August 15, 2024**Addendum No. 02****File Reference Number: RFP 2024 041****Title: Cochrane Yard Office Upgrades and Repair****RE: Clarifications/Questions**

**FLOOR & LOCATION PLANS, ELEVATIONS,
 SECTION & LIST OF DRAWINGS**

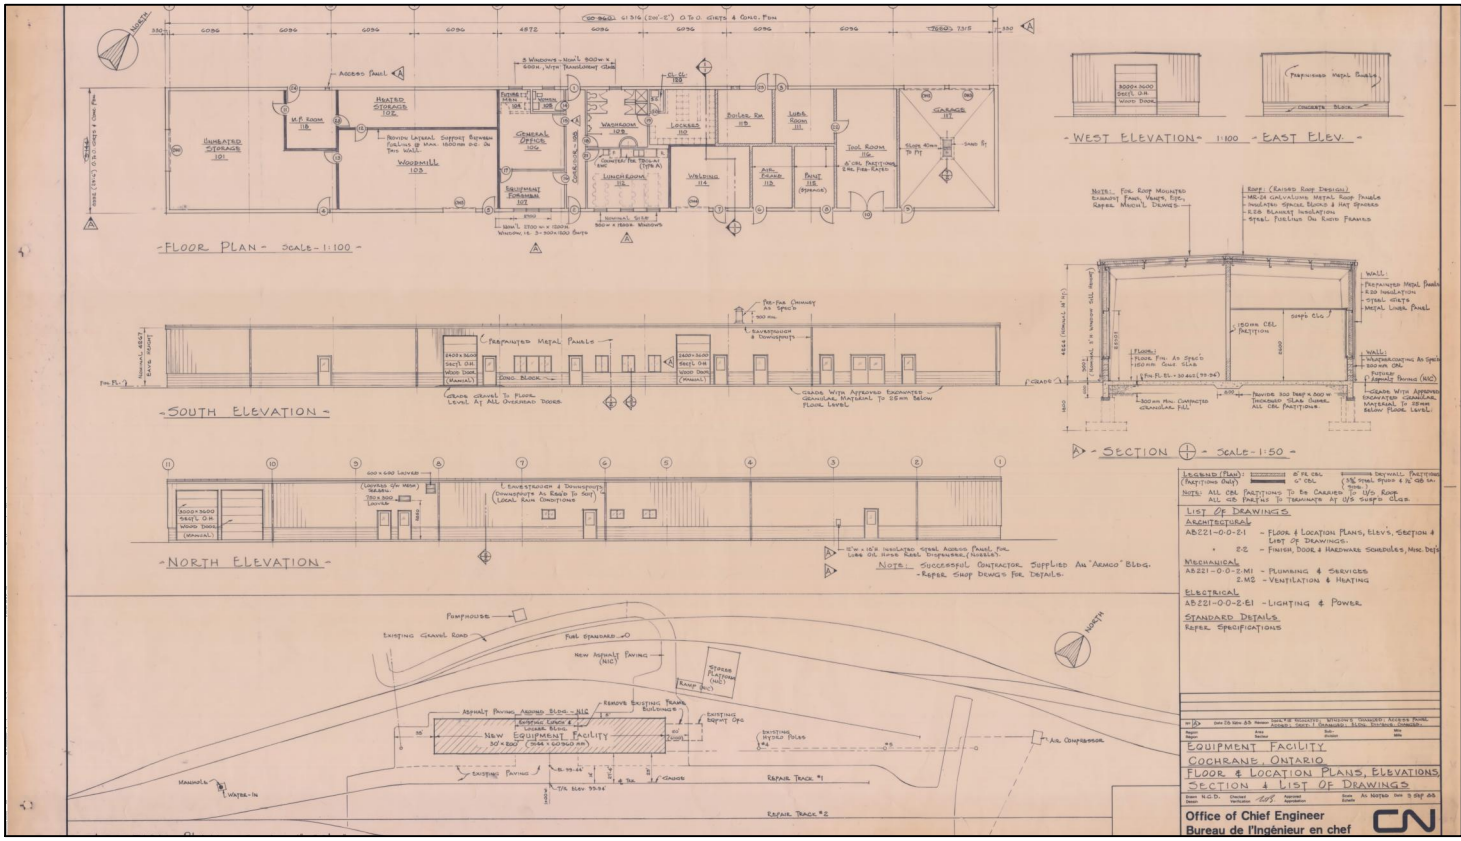
Item 11: General Note #6 states that all existing doors are to have new frames. If this is accurate, could we receive the door schedule and specifications as well?

- i. Door #6 on original drawings has been removed
- ii. Small Addition on east side has 1x single door and 1x double doors. The size of those door will need to be confirmed.

Overhead door required quantity and size to follow shortly. Some of the overhead doors will not be replaced.

Answer: There is an existing door schedule on the original drawings for the building with some exceptions: (attached)
